due to some claims of customers using the SPI Interface and previously modules with we herewith inform as follows:

Here again the table of the IST3004-TX SPI Timing as per Spec. Ver.003:

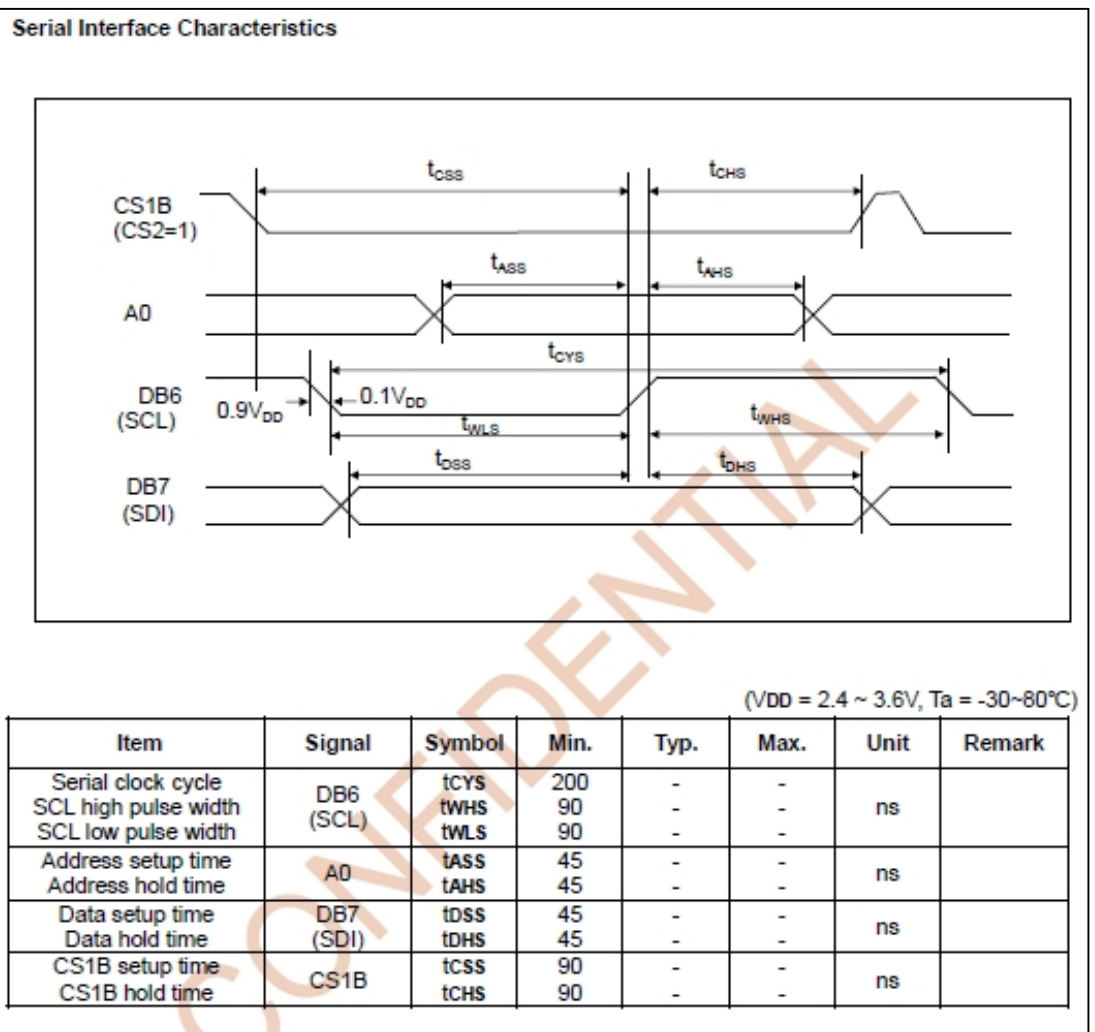
In many cases customers using SPI Interface the timing needs to have special attention.

It is important to understand that the command/data signal (A0) needs to be set only after the chip select (CS) is set.

The previous IC was faster and not that sensitive to this issue and allowed the A0 to be set before the CS.

We recommend the following INT-CODE proposal for the SPI-Interface:

void data_trans(unsigned char tdata)
{
    uchar i;
    CS=0; //The CS must be before the A0
    A0=1;
    SCL=0;

void ins_trans(unsigned char tcom)
{
    uchar i;
    CS=0; //The CS must be before the A0
    A0=0;
    SCL=0;
